E2230A-04

S E R V I C E N O T E

E2230A

The E3858A Power Distribution Unit (PDU) used on the E2230A can affect system performance for certain measurements.

Figure 4. ESD Protector with holes enlarged.

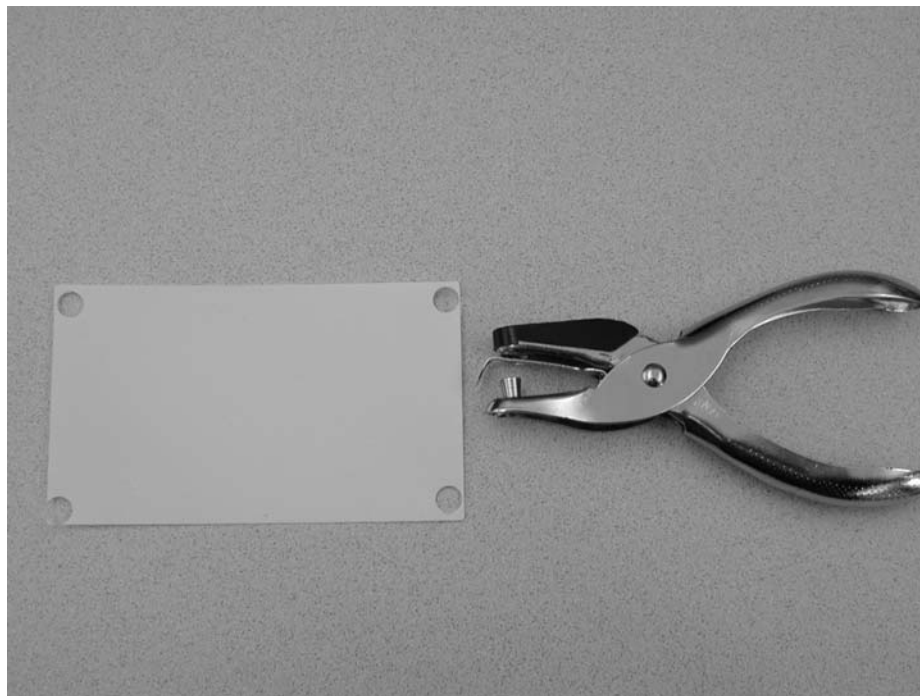
- Remove the white plastic ESD protector from the chassis.
- Enlarge the holes on the plastic protector using a hole punch (Figure 4).

Figure 6. Removing the wire from pin six.

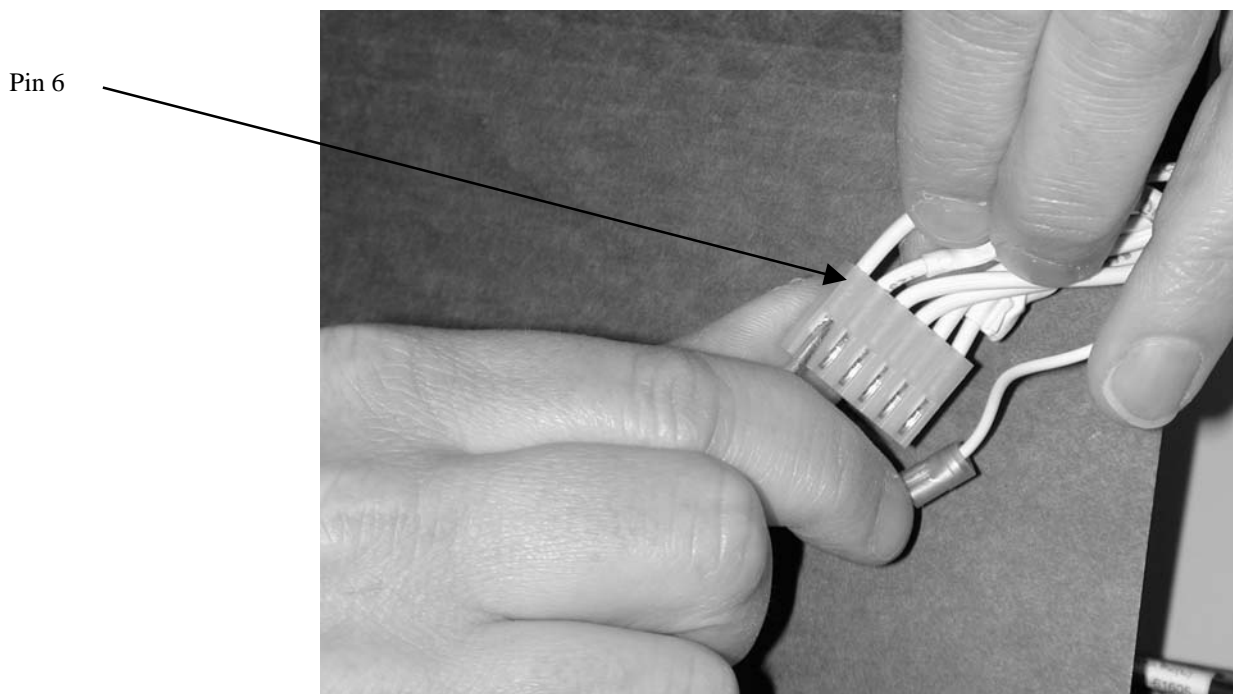
- Modify cable E3858-61607 as follows:
 - Remove the wire from pin 6 of the 6-pin connector. See Figure 6 for connector orientation to locate pin 6.

Figure 7. Adding a Wire With a Ring Connector to the Pin 6 (E3858-61607) Wire.

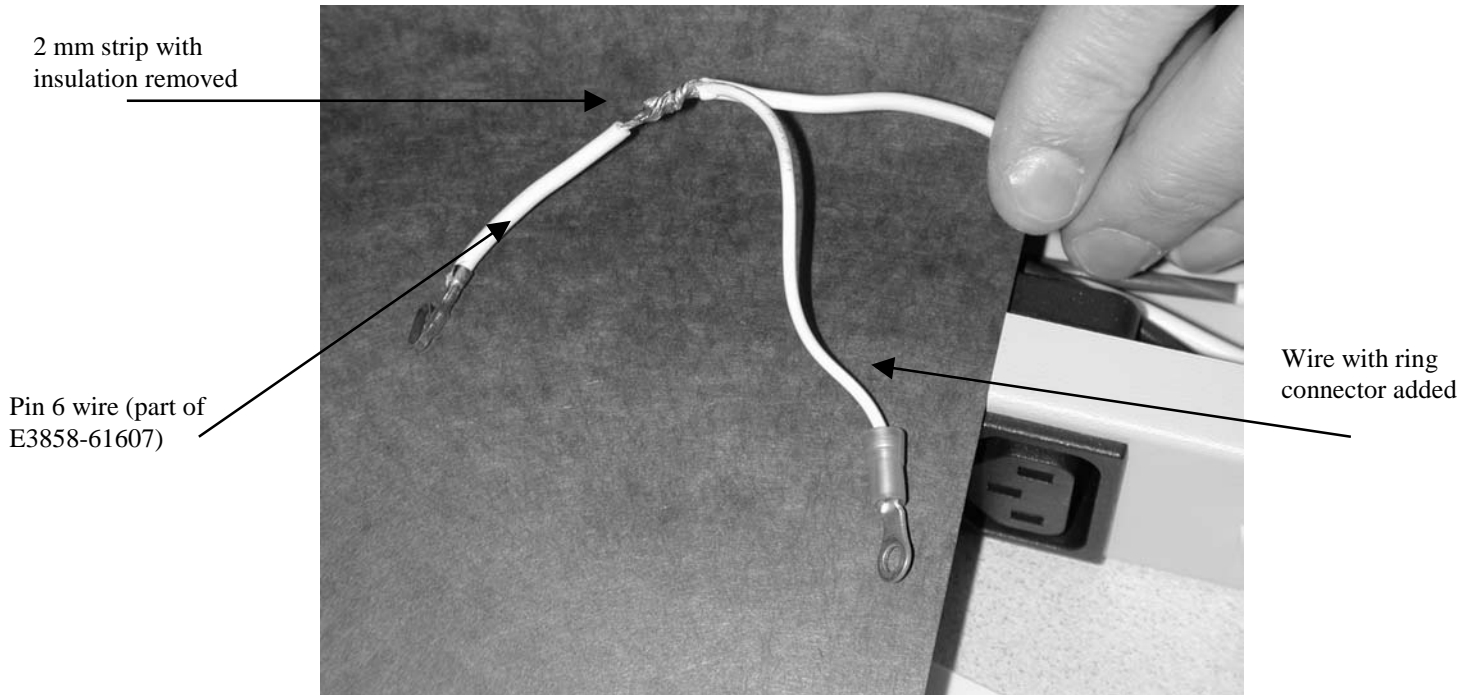
- Remove approximately 2 mm of insulation from the wire starting at 8 mm from the connector pin (Figure 7). Do not cut the wire.
- Using a piece of 20 AWG UL1061 wire 50mm long, remove approximately 8 mm of insulation from each end.
- Connect a ring terminal to one end of the wire. Solder the other end of the wire to the 2 mm strip of the pin 6 wire (part of E3858-61607). See Figure 7.

Figure 8. Heat shrink in place.

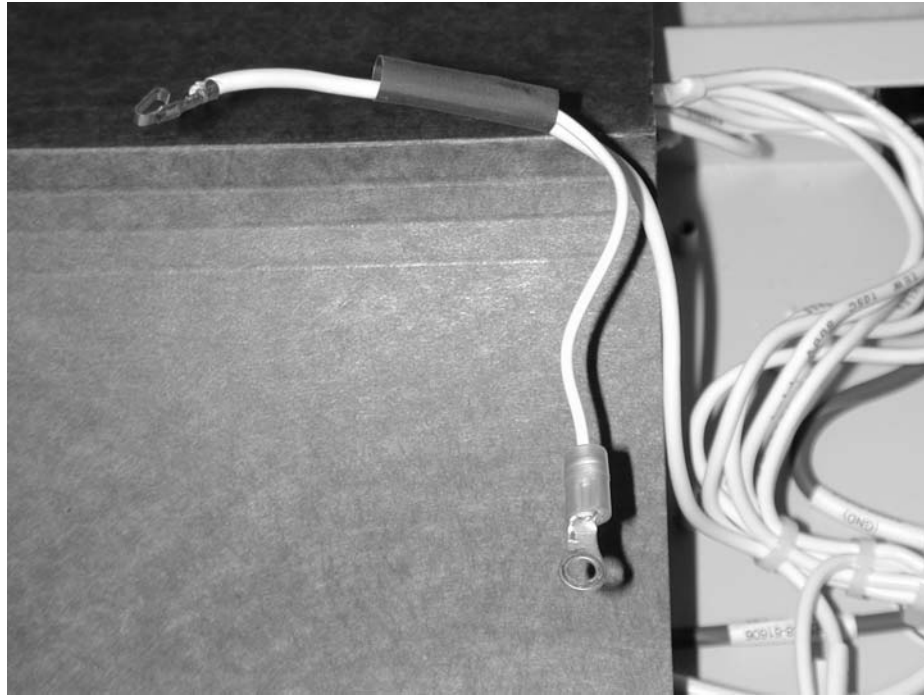
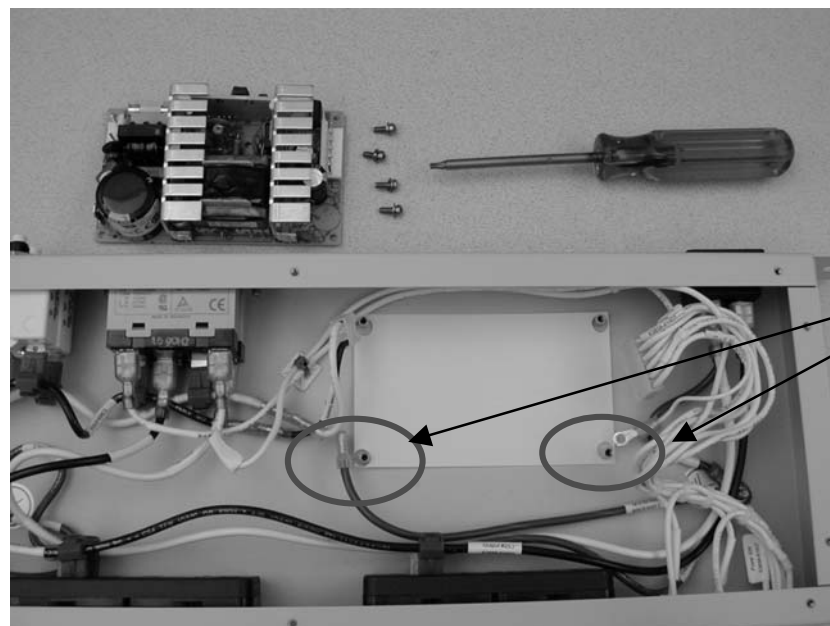
- Add a piece of heat shrink tubing (20mm long) over the soldered section (Figure 8). Use a heat gun to seal the heat shrink.

Figure 10. Re-installing the Power Supply and Connecting the Ground Wire to the Post.

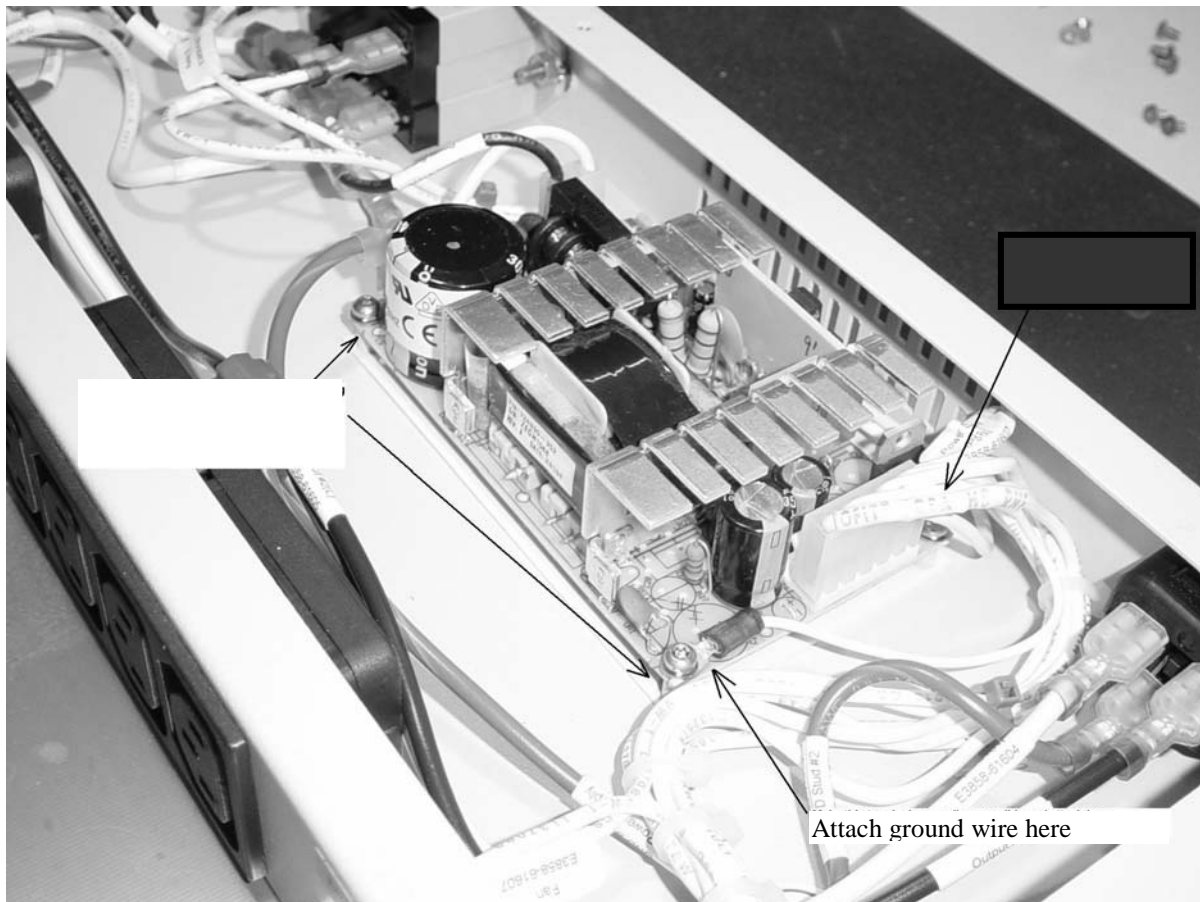
- Reinstall the power supply in the PDU chassis using the four screws. Attach the ground wire from the pin 6 wire to the post as shown in Figure 10. Reattach cables E3858-61614, E3858-61607, and E3858-61606 that were removed previously (Figure 2).

Figure 11. Measure Continuity Between these Points.

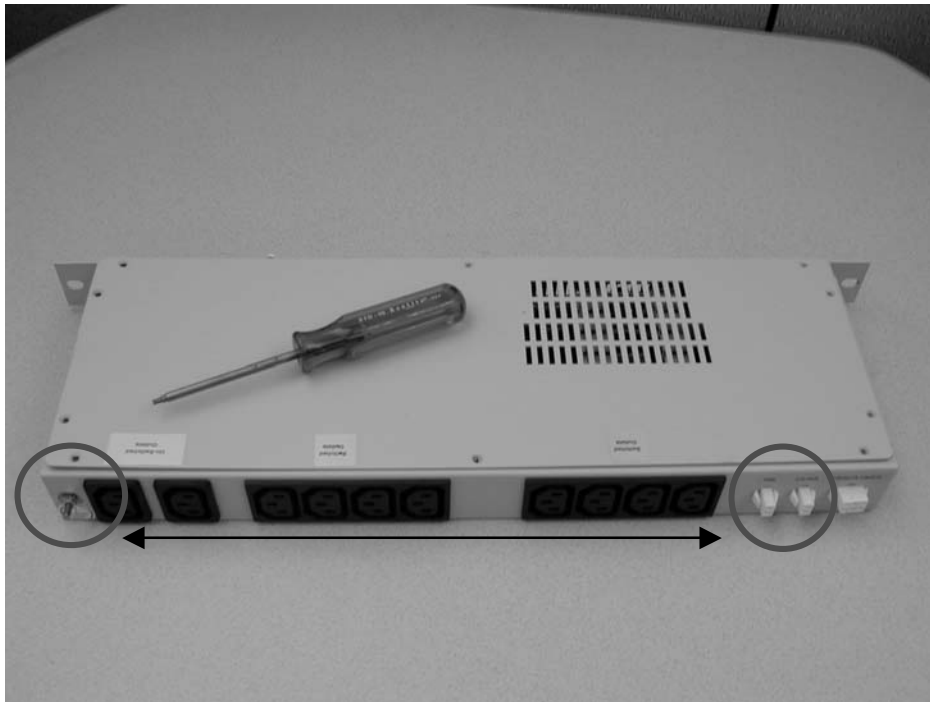
- Replace the PDU cover. Verify proper installation of the ground wire by checking continuity between the ground terminal and the bottom (LO) pins of the connectors shown in Figure 11. Re-install the unit in the system rack.
